SOUTH HOLLAND DISTRICT COUNCIL

Outline Planning Permission

Reference: H11/1313/91 Received:17-OCT-91 Type:OUTLINE

Description: One residential building plot
(registered as H11/0783/91)
Location : Wisbech Road Long Sutton
Spalding Lincs

Plan attached to Decision Notice

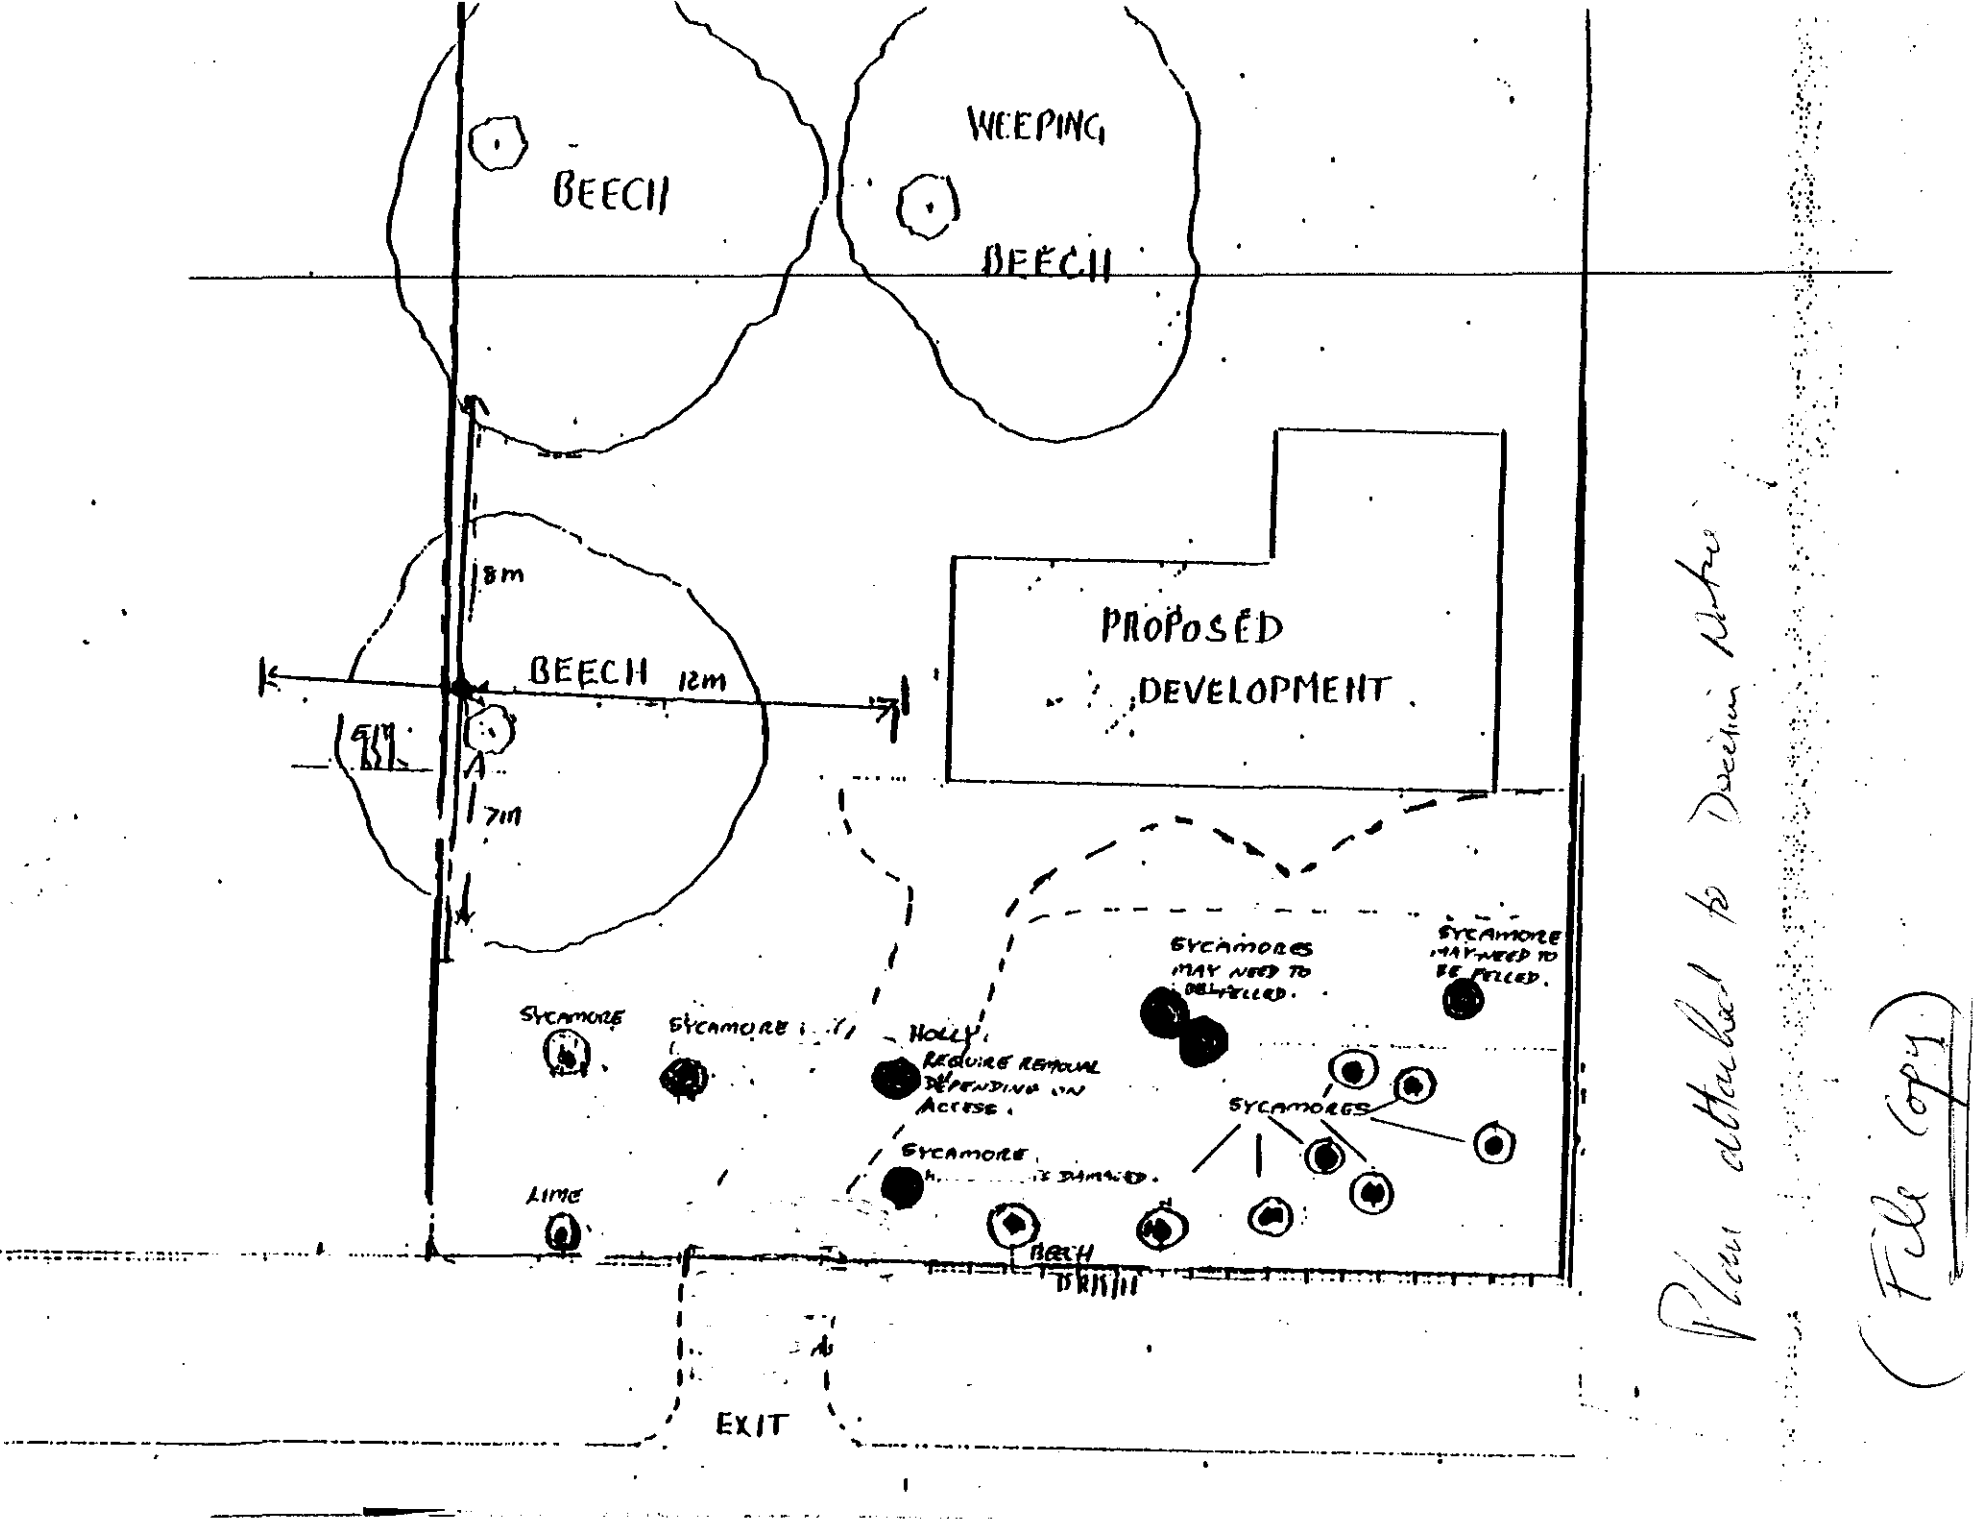
Three Sycamores were identified as likely to require felling (due to closeness to the proposed dwelling) should the proposed development take place. These are marked on the attached plan. These trees are the largest Sycamore trees present on the site, if they were removed, the site would still be partially screened from the road with those small trees remaining.

If the holly is accurately plotted on the plan. It will require removal to allow the proposed access drive to be built. It might be possible to transplant this tree.

If the proposed development goes ahead, Three Sycamore trees may eventually require felling, which grow with 6.8m of the proposed dwelling. The removal of the Southernmost tree with the Tw 'V' form will be most noticeable from the roadway. The removal of the other two will tend to be compensated by the smaller trees growing in front, which are likely to show increased growth, as there will be reduced competition for light, nutrients and water.

The applicant is advised that this approval does not authorise any works to trees within the site preserved under the Long Sutton Tree Preservation Order No. 19. The Local Planning Authority would not however object to an application to fell the trees indicated on the plan attached to the decision notice.

The applicant is advised that this approval does not authorise any works to trees within the site preserved under the Long Sutton Tree Preservation Order No. 19. The Local Planning Authority would not however object to an application to fell the trees indicated on the plan attached to the decision notice.

POSITION AND SPREAD - of TREES

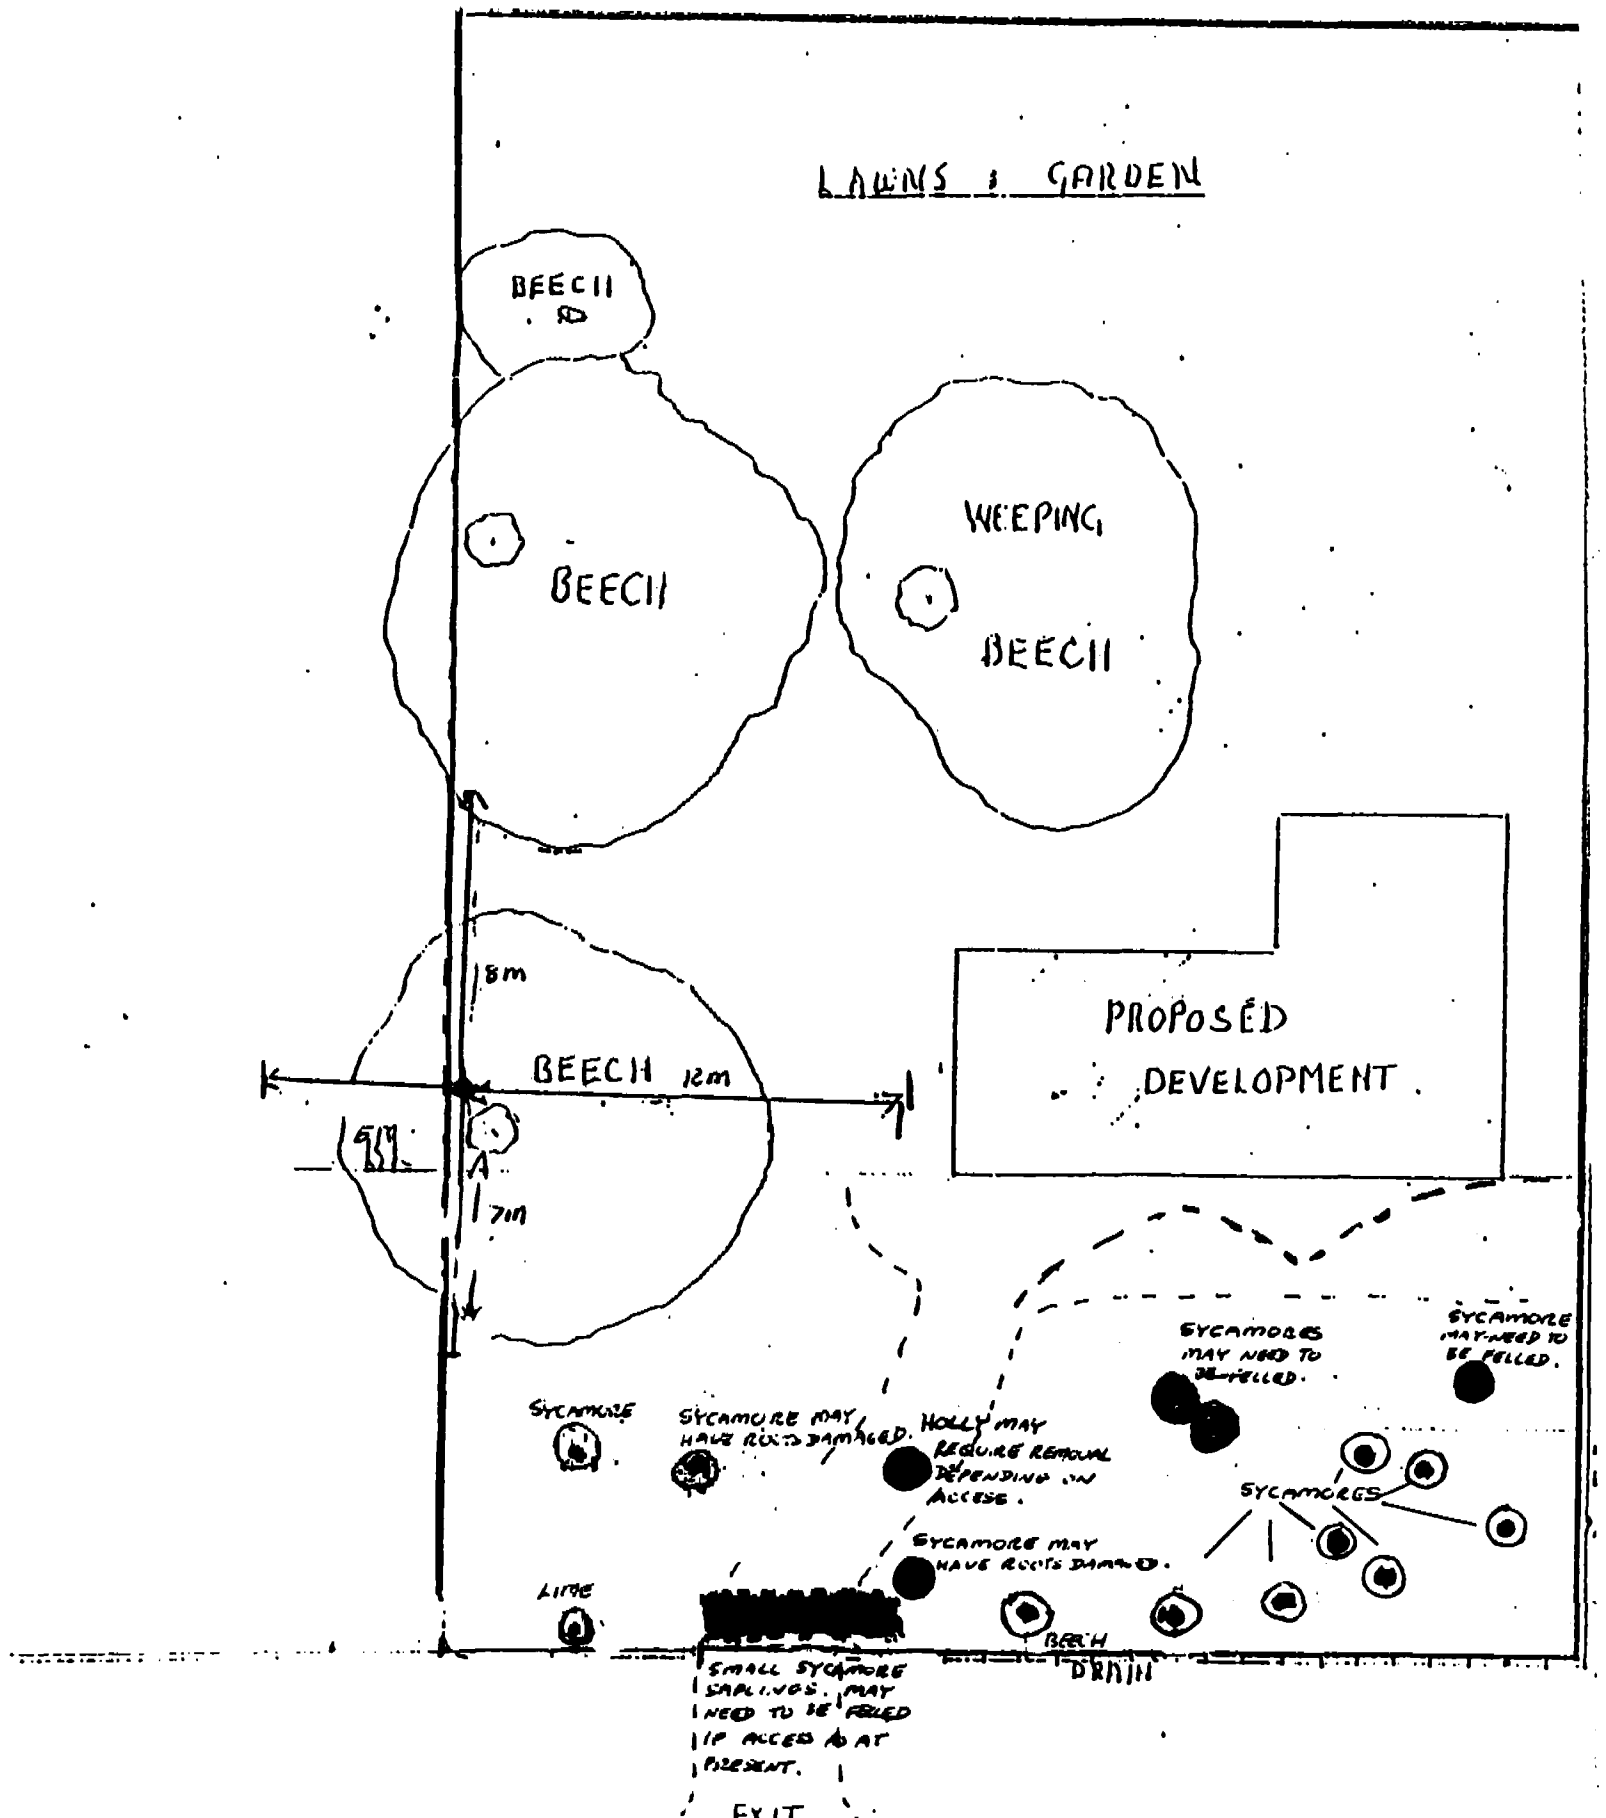
The trees are all plotted on the plan. (May be some possible confusion regarding the Beech on the frontage in relation to the adjacent Sycamore) some very small sycamore saplings may have been omitted.

General comment of A1 and A2 concerning sycamores/beech saplings: many young sycamores could be thinned out to allow other specimens to grow eg; those in north west corner of A1 near a beech tree. Also, some young beech saplings on the southern side of A1 could possibly be replanted, before they grow larger, may be already too large.
